SUBJECT: **Safety Tipping Point Overloaded:**  
"Sight Distance Study" & Proposed Plat  
for "5th Street Bluffs Subdivision"

**Re: Sight Distance Study for Proposed Driveway  
John Chaney Property on W. 5<sup>th</sup> Street**

In re: PP-04-01-08  
A Preliminary Plat for Fifth Street Bluff 0.29 Acres Subdivision  
Consisting of One Lot Located at 427 Country Club Court.

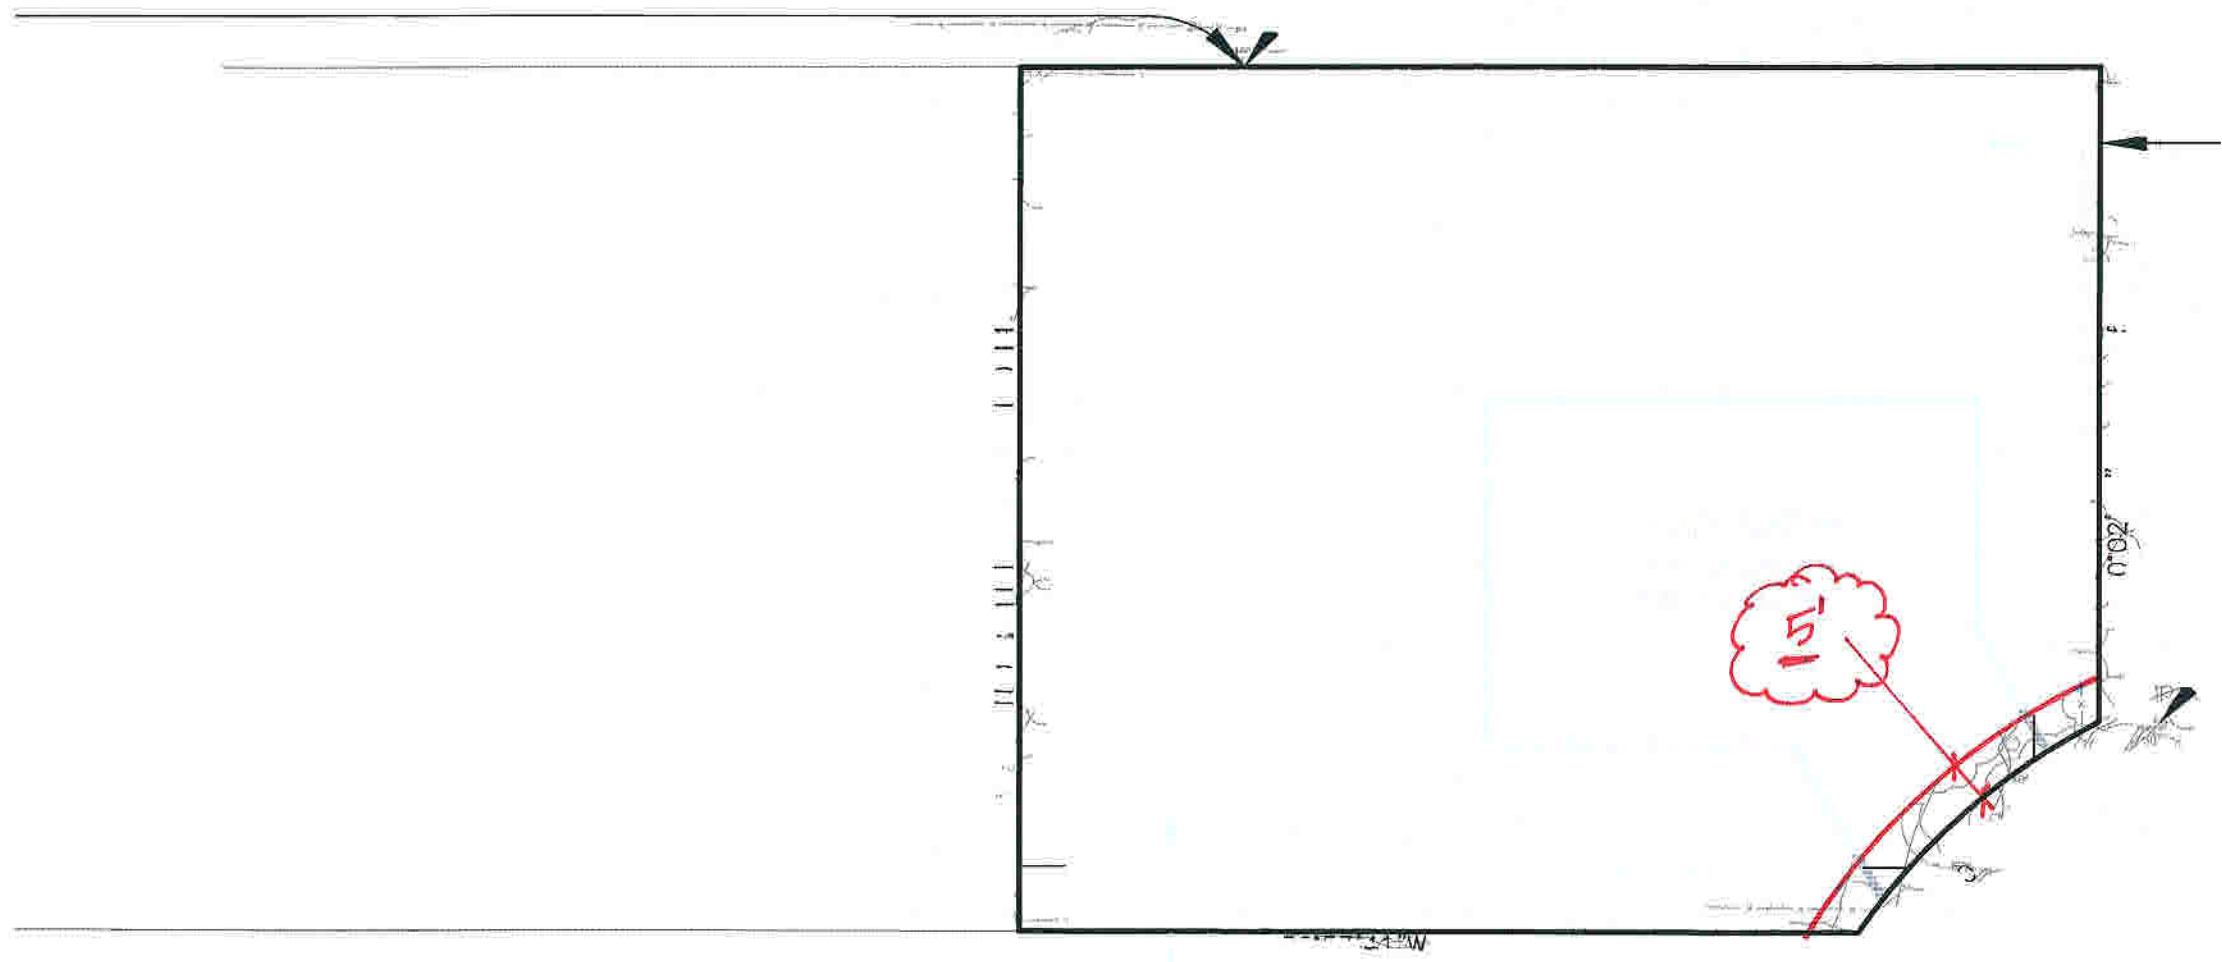
Would you please include this graphic in the packet to the Commissioners. I think they have been furnished another graphic that is completely out of scale. I think it is relevant to keep in perspective what 5' looks like in the scheme of things.

FROM ORIGINAL "GRANDVIEW HEIGHTS" SUBDIVISION PLAT OF RECORD

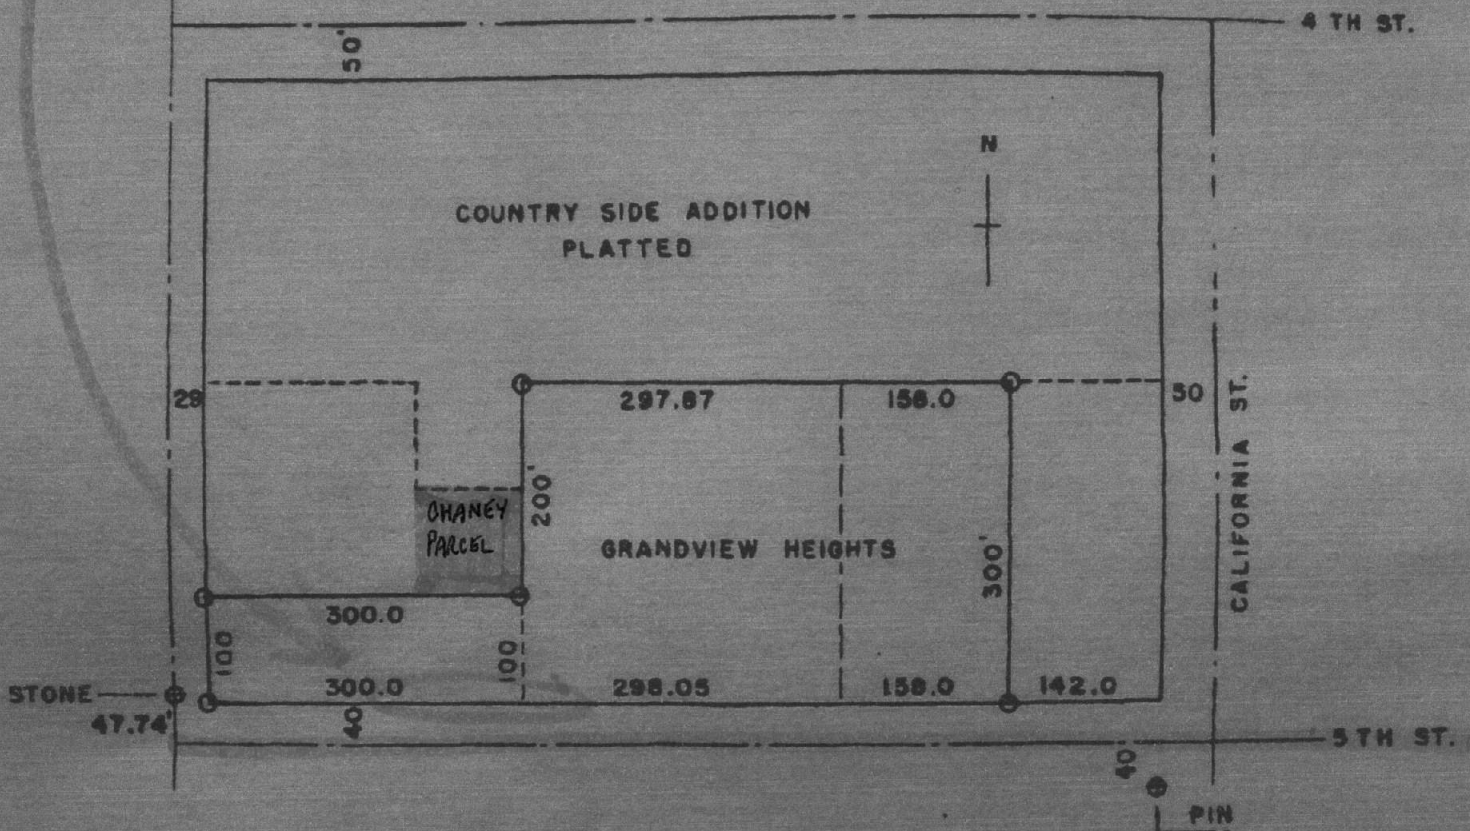
Further: The existing plat for Grandview Heights omits the subject unplatted parcel entirely from its intended neighborhood planning. No stated intent for access is indicated. Indeed, the block-form "PLATE" appearing lower left on that subdivision plat **EXCLUDES** any access point whatsoever to the subject parcel along 5th Street. This suggests that the **exclusion from 5th Street was quite intentional and made visibly explicit by safety-minded, thoughtful planners of the past.**

# NO 5th St. Frontage

**SIGHT DISTANCE EXHIBIT**  
JOHN CHANEY PROPERTY  
LAWRENCE, KANSAS

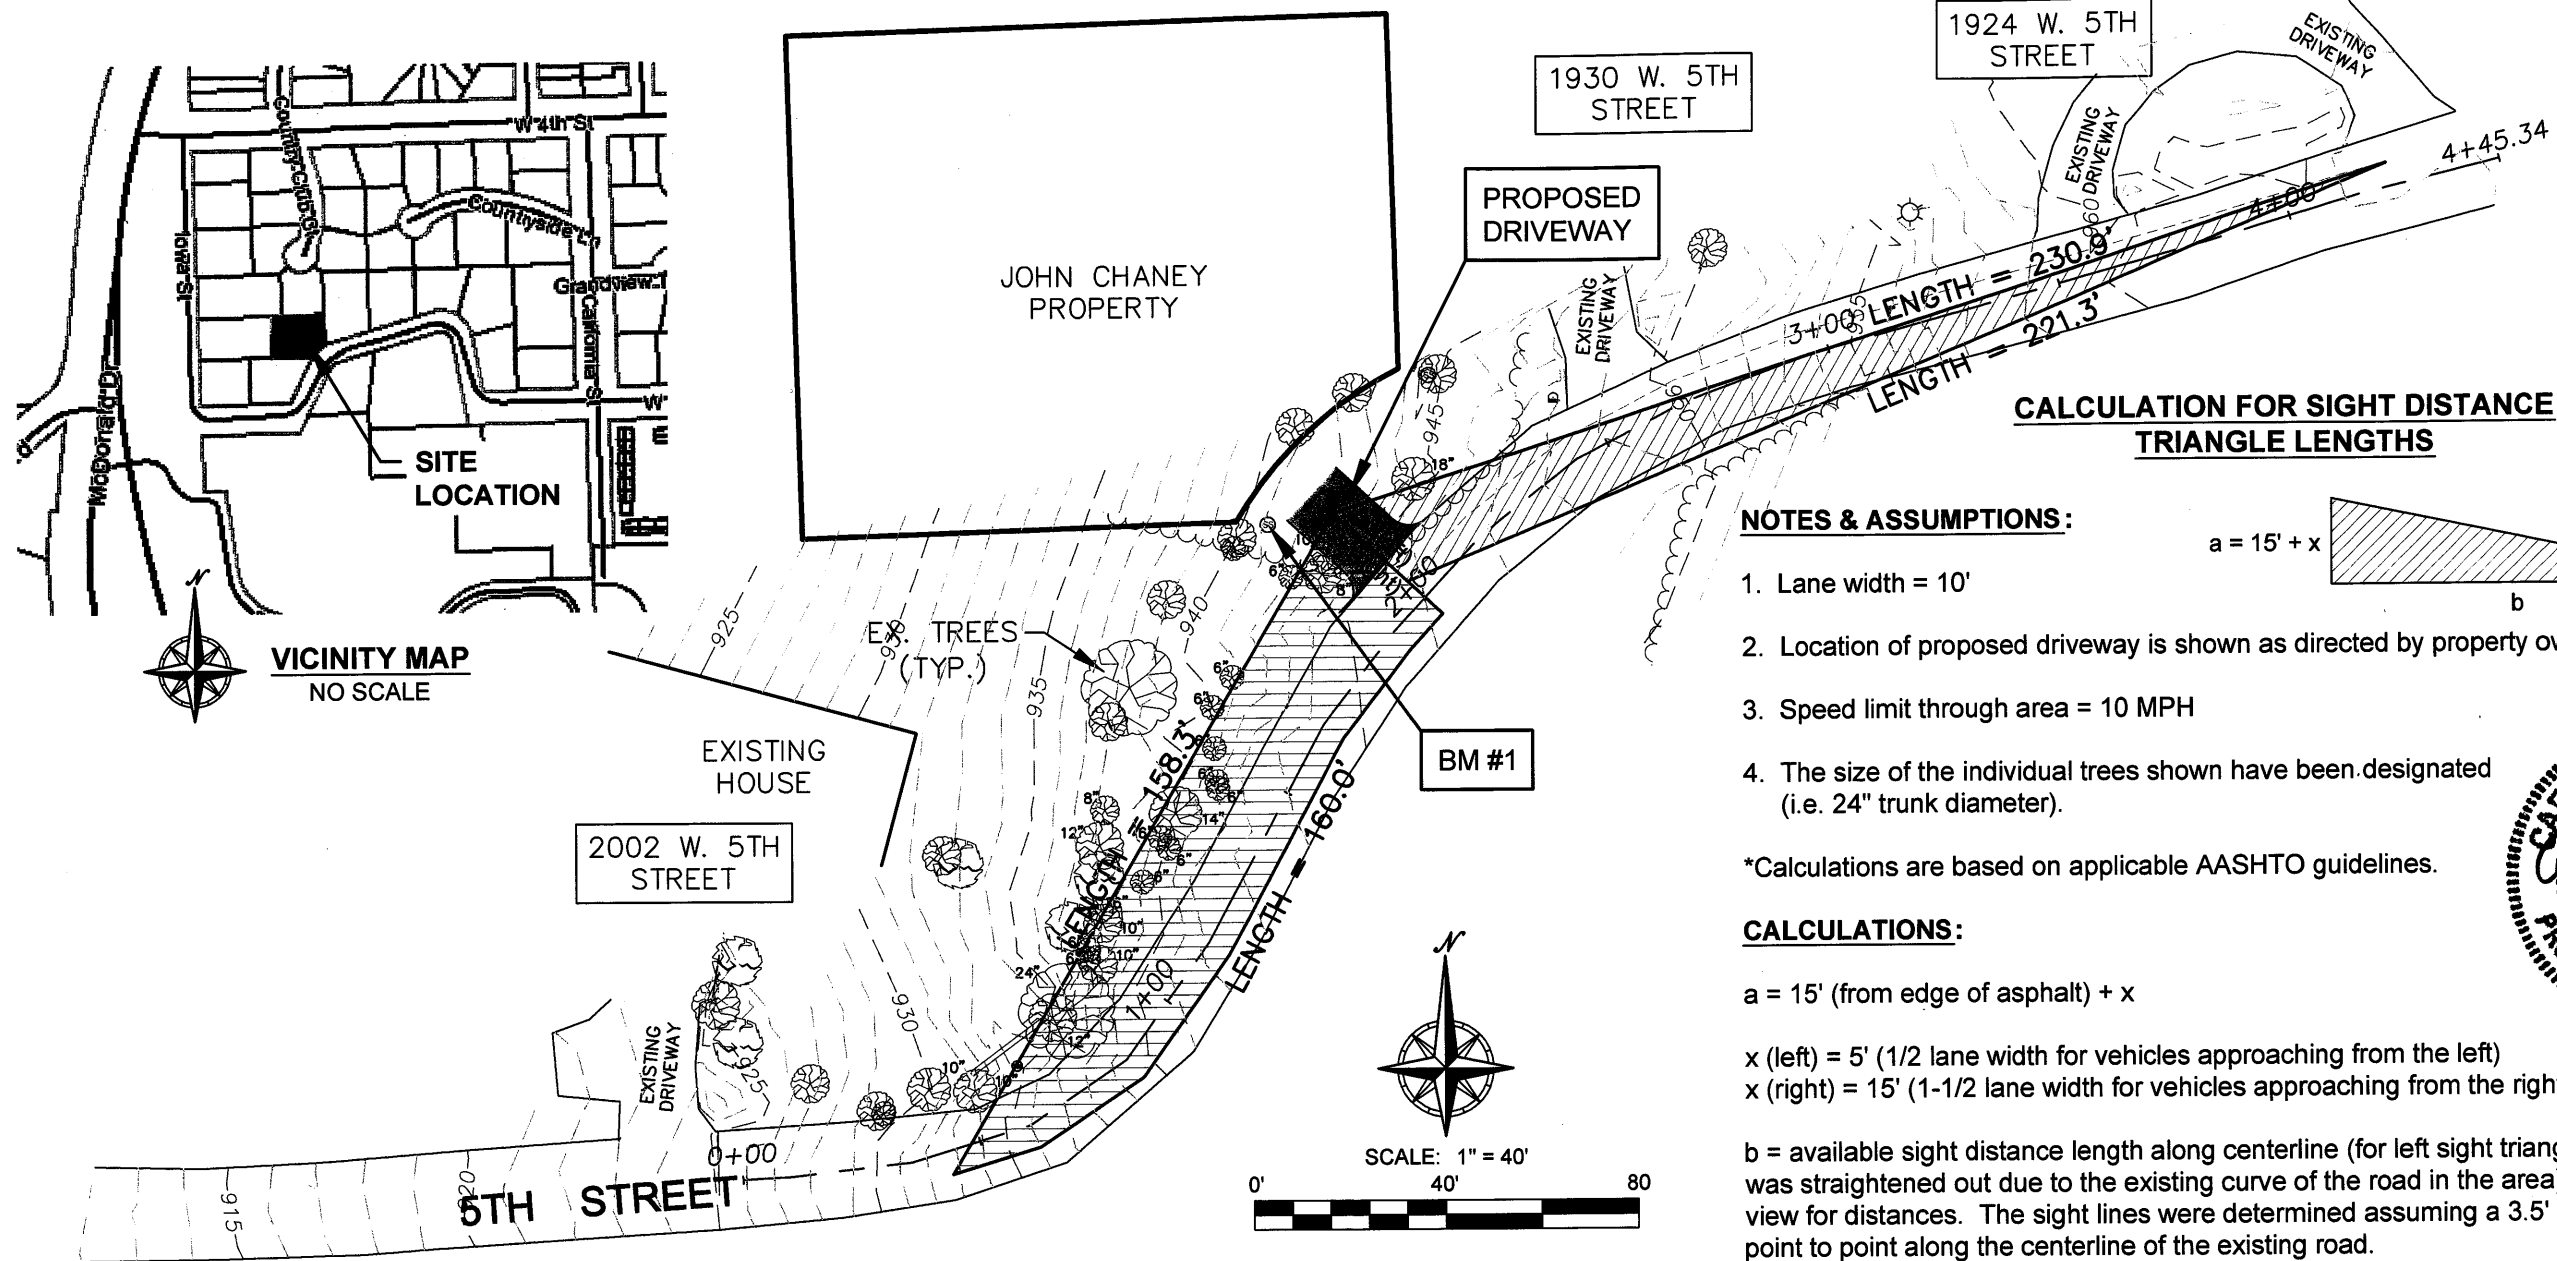
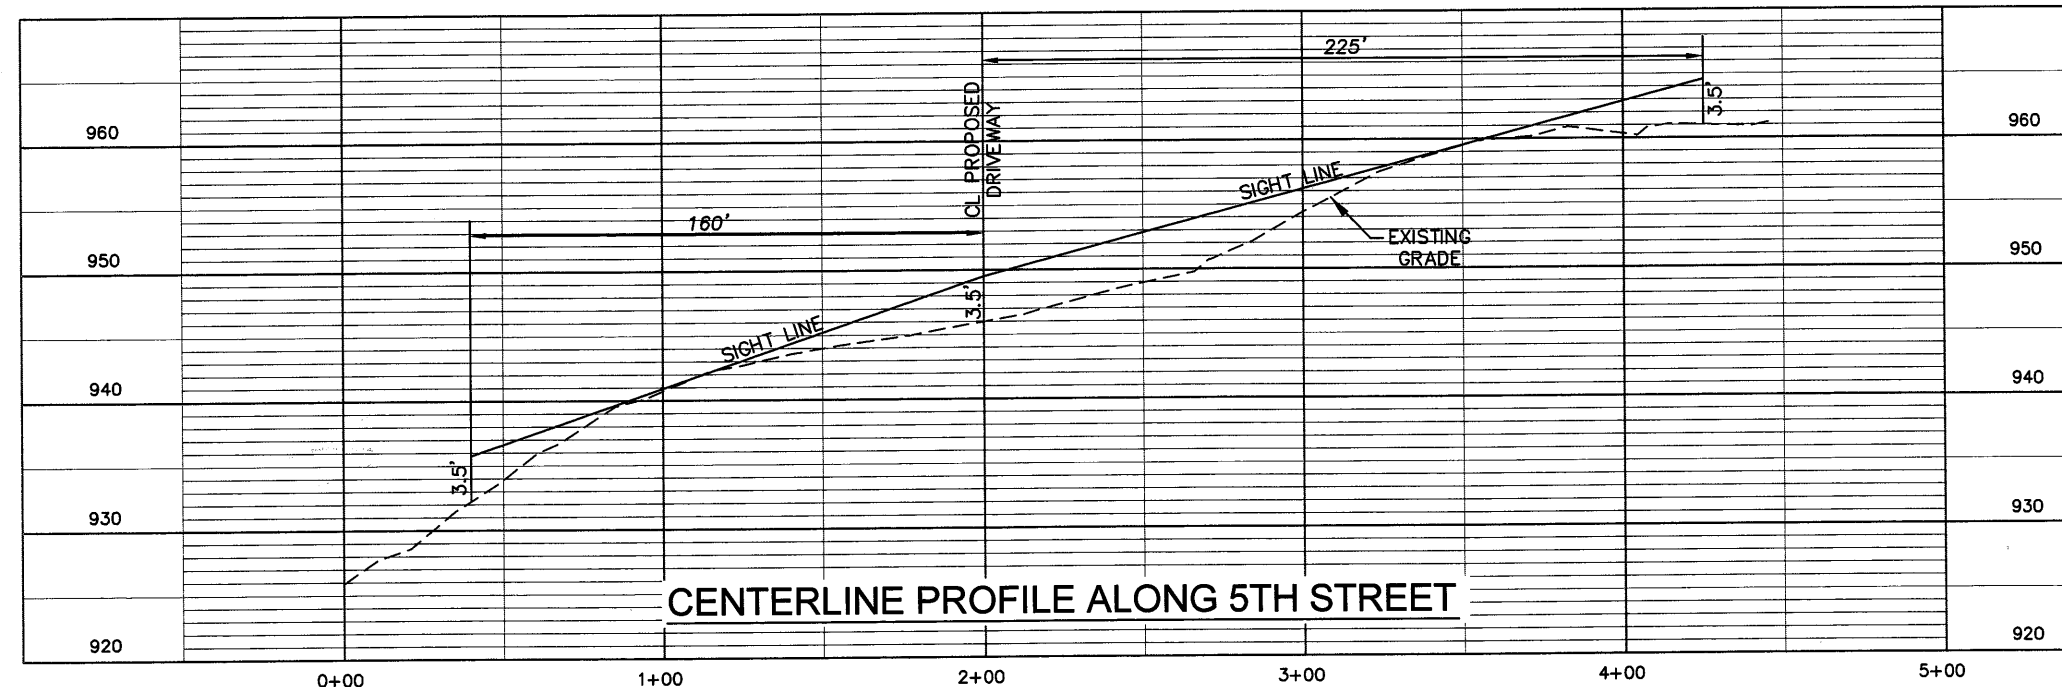
**ACCESS IS BEING SOUGHT ALONG A NARROW, RESTRICTING, UNLIGHTED CURVE ON A STEEP, TWISTING, OLDER STREET WITH NO SHOULDERS, OTHER SAFETY MARGINS, OR WIDTH TO PASS. Visualize a short, tight "chicane" with soft ditches, no direct street lighting, and no inviting escape path from any imminent collision.**

**The specific point of proposed access is inherently and especially dangerous for additional reasons including the following:**

- ◆ At present, no existing hillside driveway is closer than 80 feet to the next on the same side of this immediate, sloping section of West 5th St. Slashing that safe distance to under 40 feet at the location of the proposed driveway **would introduce added, near-certain collision probability over time** for drivers exiting the now two, too-close driveways. Further: Transiting traffic arriving westbound from above may not see cars with drivers hesitantly exiting either driveway in time to brake or evade collision. Darkness would increase probability of collision and the considerable likelihood of serious injury. "Sight distance triangles" do not provide nighttime illumination or quicker reaction times.
